PCI-SIG DRAFT ENGINEERING CHANGE NOTICE

TITLE:	Completion Timeout Control Capability
DATE:	27 April 2005, updated 12 August 2005
AFFECTED DOCUMENT:	PCI Express Base Specification Revision 1.1
SPONSOR:	David Harriman, Intel Corporation

Figure 7-XX: Device Capabilities 2 Register

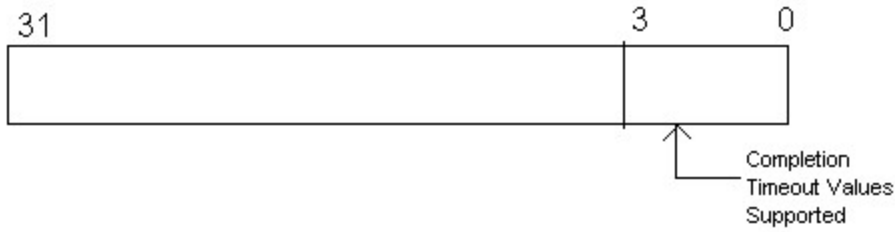
Building upon the PCI Express Capability Structure Expansion ECR/ECN, in Device Capabilities 2 and Device Control 2 Register sections, change as shown:

~~This section is a placeholder—There are no capabilities that require this register.~~

Bit Location	Register Description	Attributes																
3:0	<p>Completion Timeout Ranges Supported – This field indicates device support for the optional Completion Timeout programmability mechanism. This mechanism allows system software to modify the Completion Timeout value.</p> <p>This field is applicable only to Root Ports, Endpoints that issue requests on their own behalf, and PCI Express to PCI/PCI-X Bridges that take ownership of requests issued on PCI Express. For all other devices this field is reserved and must be hardwired to 0000b.</p> <p>Four time value ranges are defined:</p> <ul style="list-style-type: none"> Range A: 50us to 10ms Range B: 10ms to 250ms Range C: 250ms to 4s Range D: 4s to 64s <p>Bits are set according to the table below to show timeout value ranges supported.</p>

<table><tr> <td>0000b</td> <td>Completion Timeout programming not supported – the device must implement a timeout value in the range 50us to 50ms.</td> </tr></table>

<p>All other values are reserved.</p> <p>It is strongly recommended that the Completion Timeout mechanism not expire in less than 10ms</p>	0000b	Completion Timeout programming not supported – the device must implement a timeout value in the range 50us to 50ms.	0001b	Range A	0010b	Range B	0011b	Ranges A & B	0110b	Ranges B & C	0111b	Ranges A, B & C	1110b	Ranges B, C & D	1111b	Ranges A, B, C & D	HwInit
0000b	Completion Timeout programming not supported – the device must implement a timeout value in the range 50us to 50ms.																	
0001b	Range A																	
0010b	Range B																	
0011b	Ranges A & B																	
0110b	Ranges B & C																	
0111b	Ranges A, B & C																	
1110b	Ranges B, C & D																	
1111b	Ranges A, B, C & D

Figure 7-XX: Device Control 2 Register

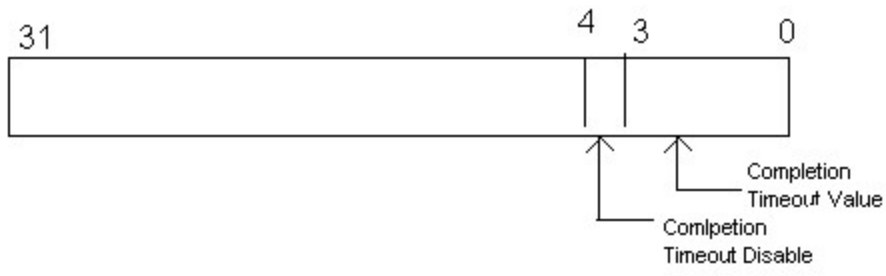
This section is a placeholder—There are no capabilities that require this register.

Bit Location	Register Description	Attributes
3:0	<p>Completion Timeout Value – In Devices that support Completion Timeout programmability, this field allows system software to modify the Completion Timeout value. This field is applicable to Root Ports, Endpoints that issue requests on their own behalf, and PCI Express to PCI/PXI-X Bridges that take ownership of requests issued on PCI Express. For all other devices this field is reserved and must be hardwired to 0000b.</p> <p>A Device that does not support this optional capability must hardwire this field to 0000b and is required to implement a timeout value in the range 50us to 50ms. Devices that support Completion Timeout programmability must support the values given below corresponding to the programmability ranges indicated in the Completion Timeout Values Supported field.</p> <p>Defined encodings:</p> <p>_____ 0000b _____ Default range: 50us to 50ms</p> <p>It is strongly recommended that the Completion Timeout mechanism not expire in less than 10ms</p> <p>_____ Values available if Range A (50us to 10ms) programmability range is supported:</p> <p>_____ 0001b _____ 50us to 100us</p> <p>_____ 0010b _____ 1ms to 10ms</p> <p>_____ Values available if Range B (10ms to 250ms) programmability range is supported:</p> <p>_____ 0101b _____ 16ms to 55ms</p> <p>_____ 0110b _____ 65ms to 210ms</p> <p>_____ Values available if Range C (250ms to 4s) programmability range is supported:</p> <p>_____ 1001b _____ 260ms to 900ms</p> <p>_____ 1010b _____ 1s to 3.5s</p> <p>_____ Values available if the Range D (4s to 64s) programmability range is supported:</p> <p>_____ 1101b _____ 4s to 13s</p> <p>_____ 1110b _____ 17s to 64s</p> <p>Values not defined above are Reserved.</p> <p>Software is permitted to change the value in this field at any time. For requests already pending when the Completion Timeout Value is changed, hardware is permitted to use either the new or the old value for the outstanding requests, and is permitted to base the start time for each request either on when this value was changed or on when each request was issued.</p> <p>The default value for this field is 0000b.</p>	RW

Bit Location	Register Description	Attributes
4	<p>Completion Timeout Disable – When set to 1b, this bit disables the Completion Timeout mechanism.</p> <p><u>This field is required for Endpoints that issue requests on their own behalf, PCI Express to PCI/PCI-X Bridges that take ownership of requests issued on PCI Express, and Root Ports. For all other devices this field is reserved and must be hardwired to 0b.</u></p> <p><u>Software is permitted to set or clear this bit at any time. When set, the Completion Timeout detection mechanism is disabled. If there are outstanding requests when the bit is cleared, it is permitted but not required for hardware to apply the completion timeout mechanism to the outstanding requests. If this is done, it is permitted to base the start time for each request on either the time this bit was cleared or the time each request was issued.</u></p> <p><u>The default value for this bit is 0b.</u></p>	RW
